# SQUARE 487

COMMISSION OF FINE ARTS | CONCEPT REVIEW | 20 MAY 2021

SECOND SUBMISSION | FIRST REVIEW: 18 MARCH 2021

ROCKEFELLER GROUP | STONEBRIDGE

# Revised Massing A

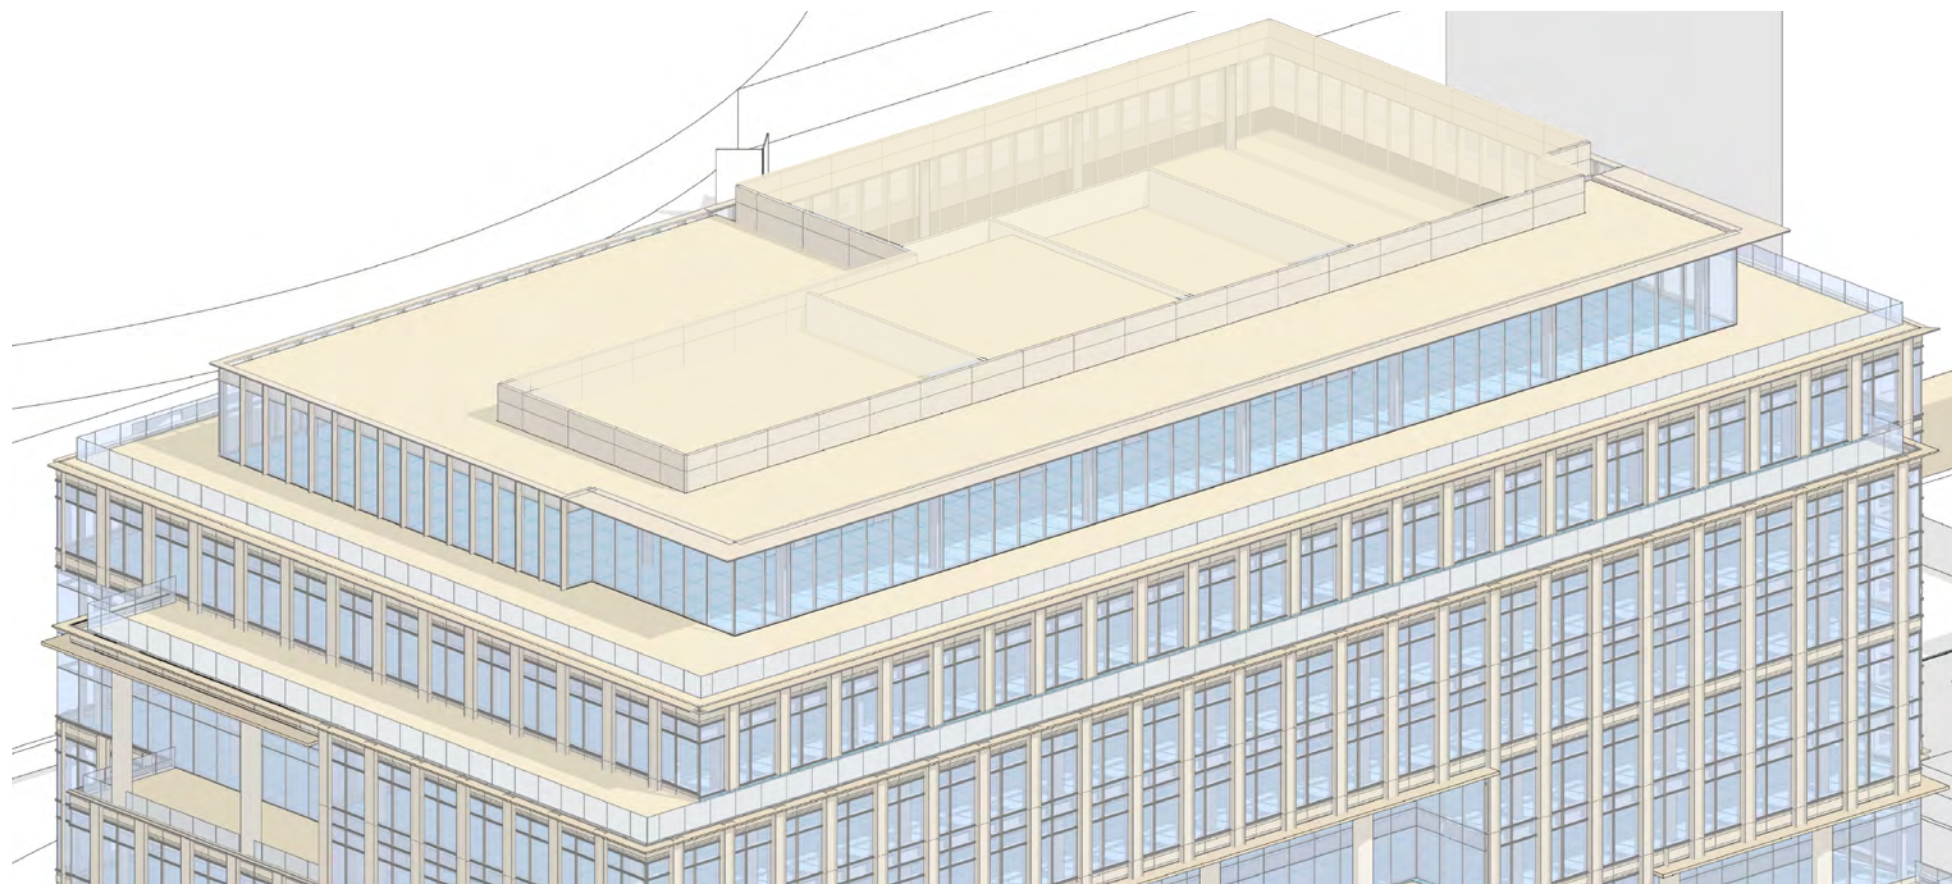
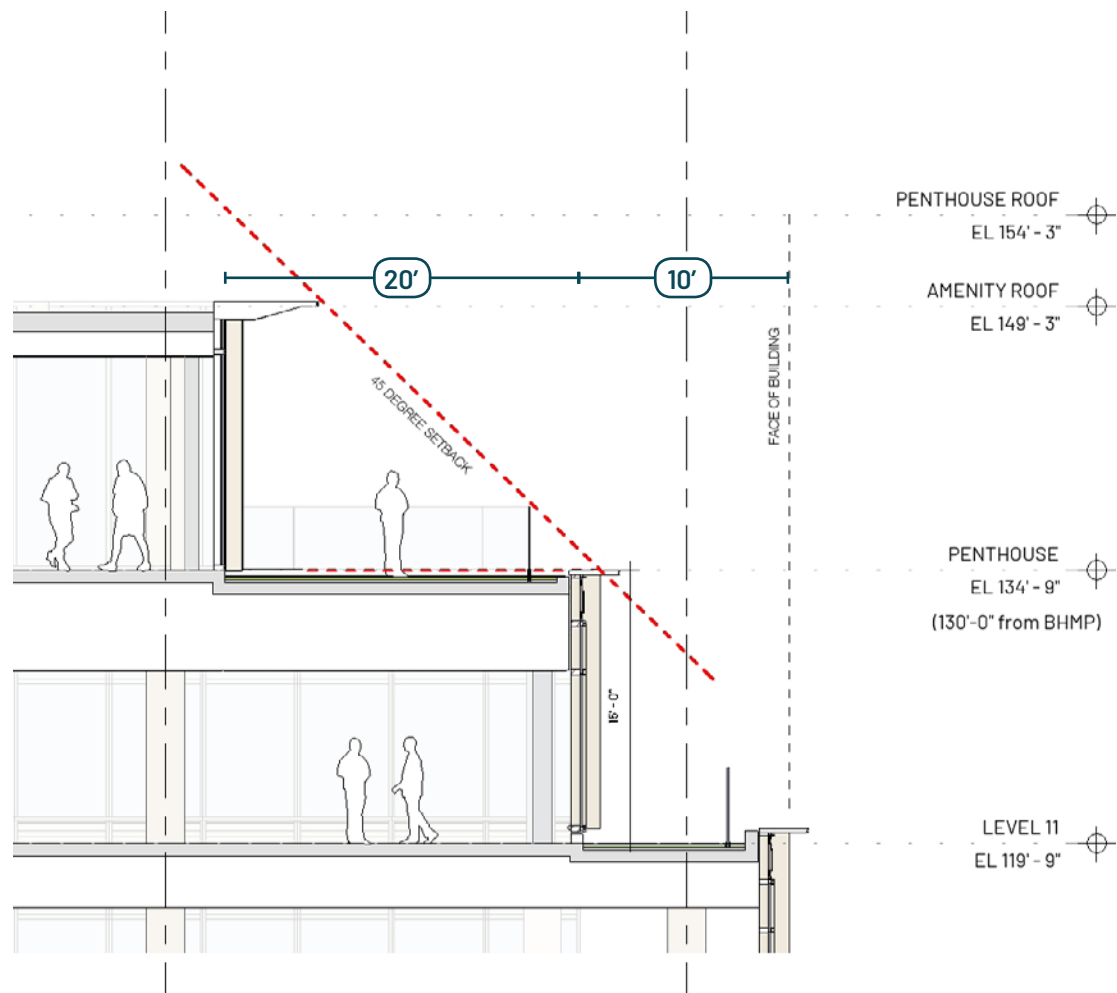
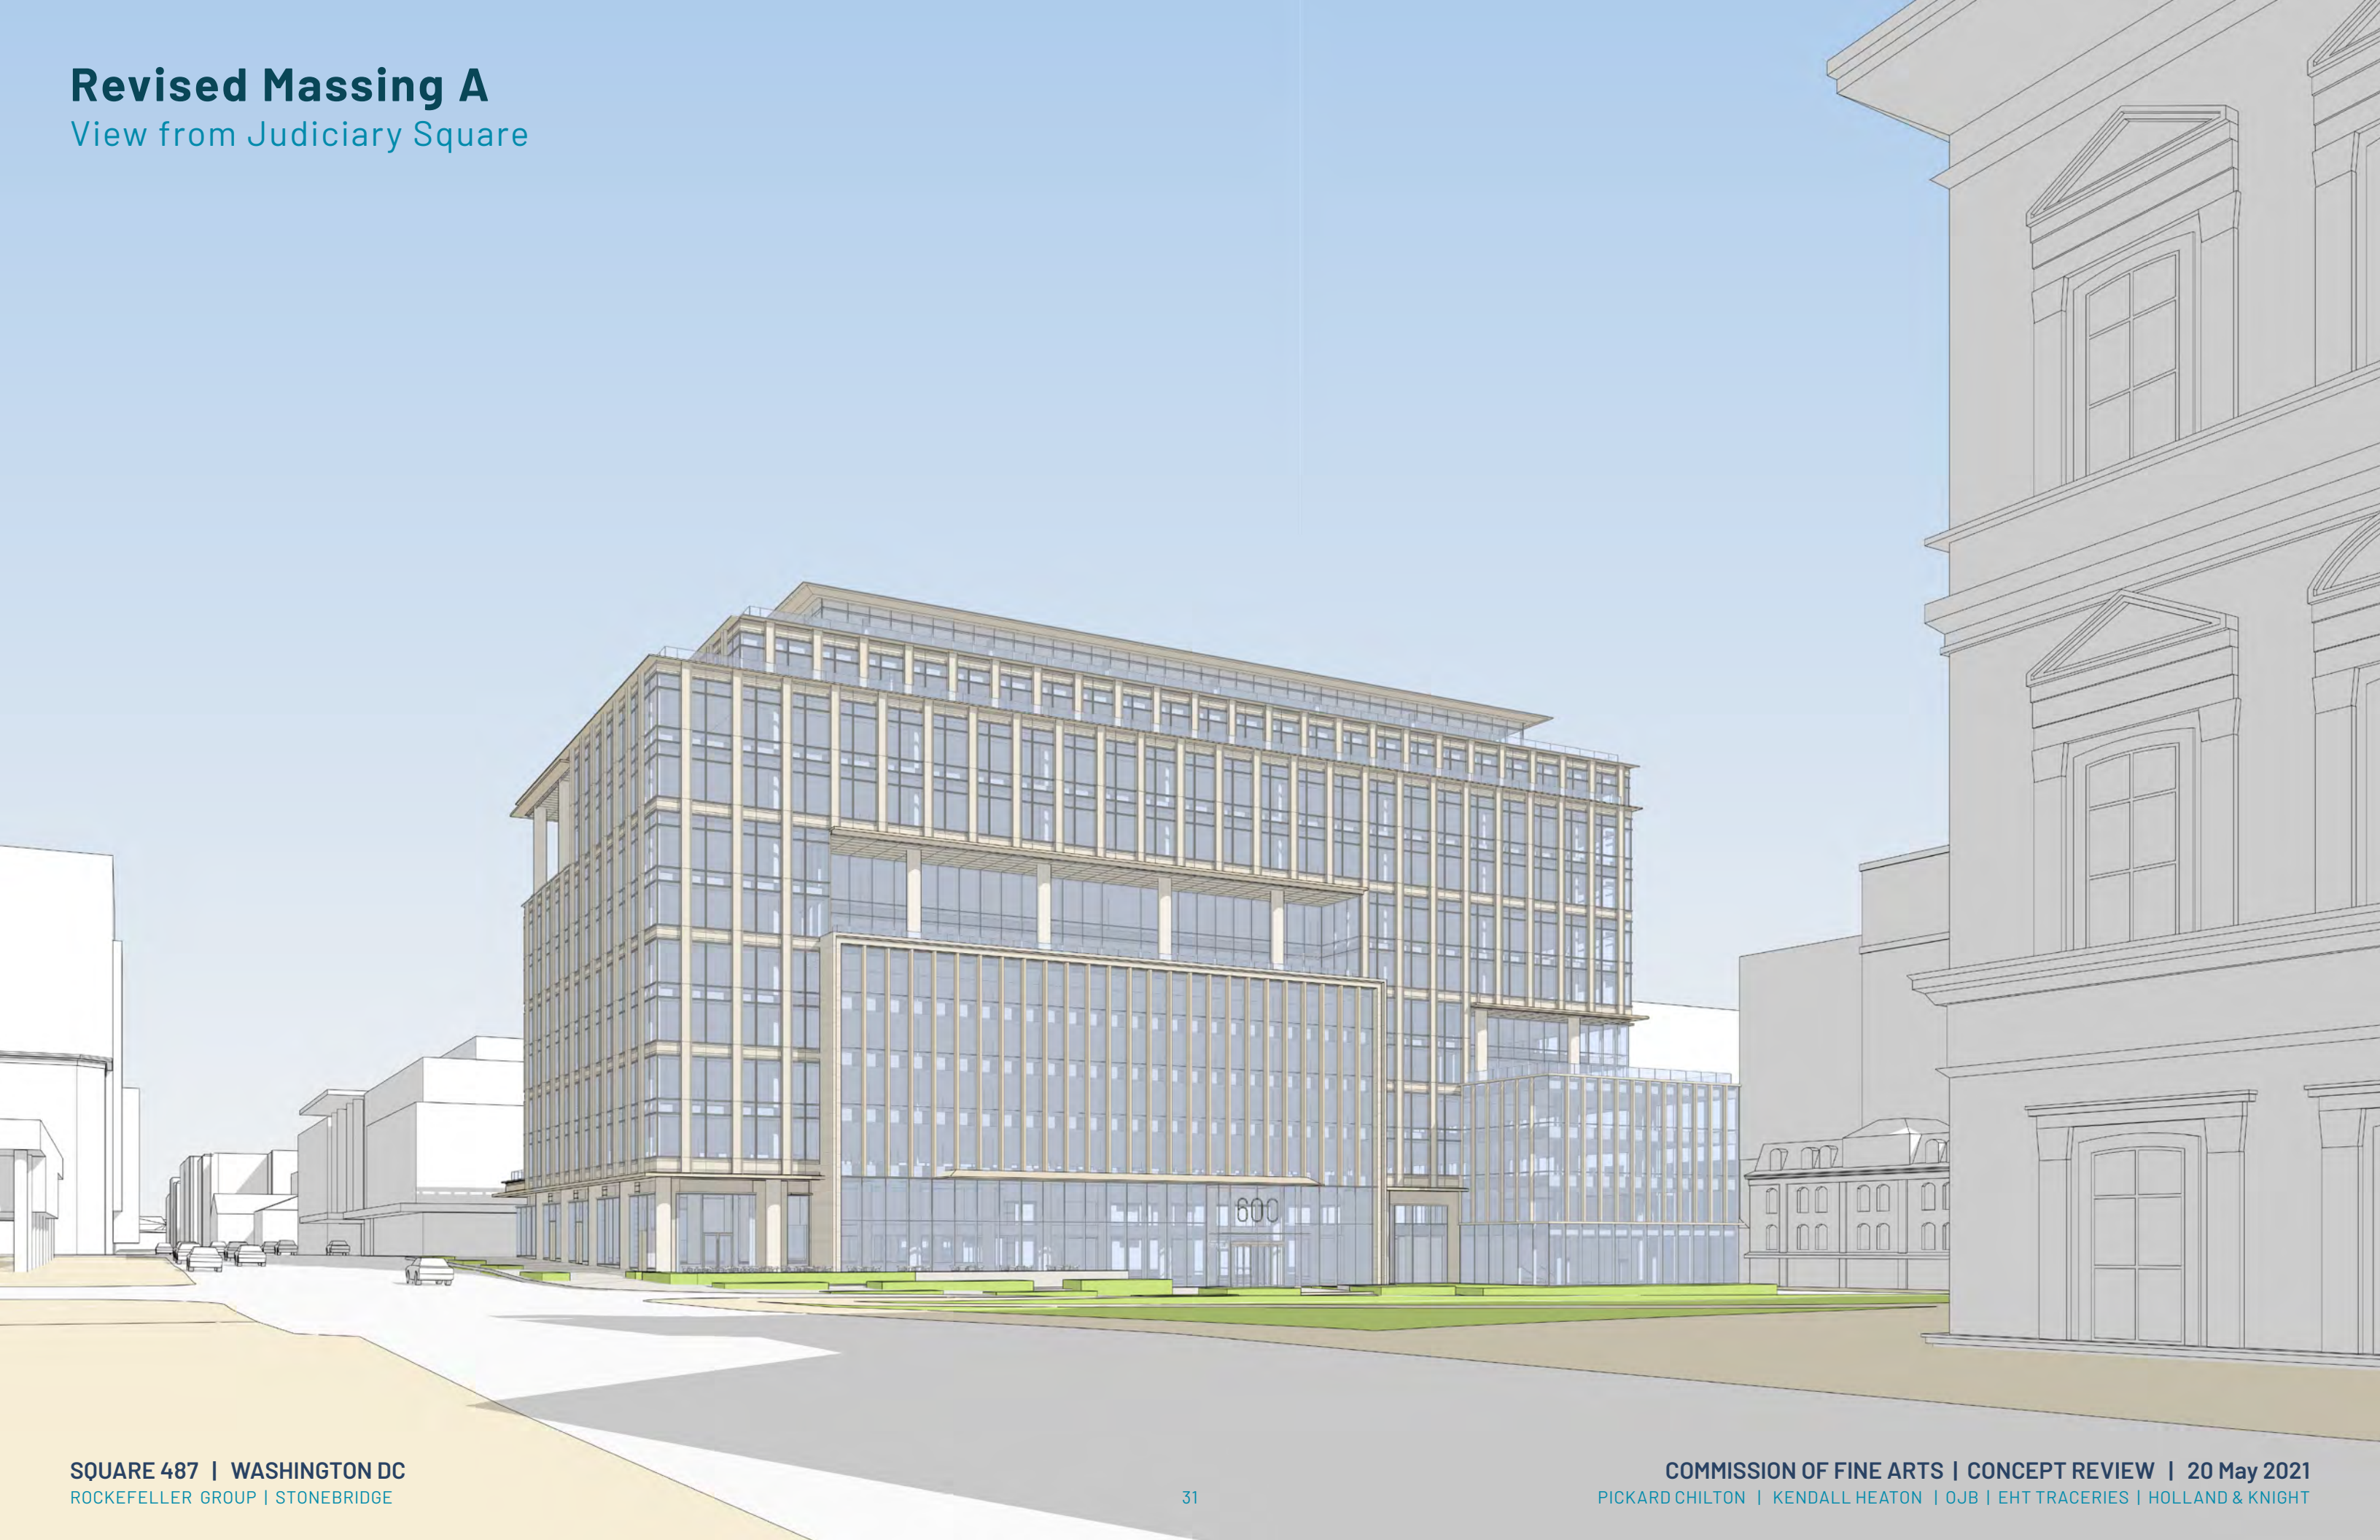
“...recommended further study of the top stories in order to minimize the impression of reflexive, incidental massing by reducing the number of step-backs and deliberately integrating the top into the overall composition of the building.”

**Penthouse** - Designed and developed options to reduce visual prominence, create shadow lines, and leverage system of brows and cornices to integrate with the overall building
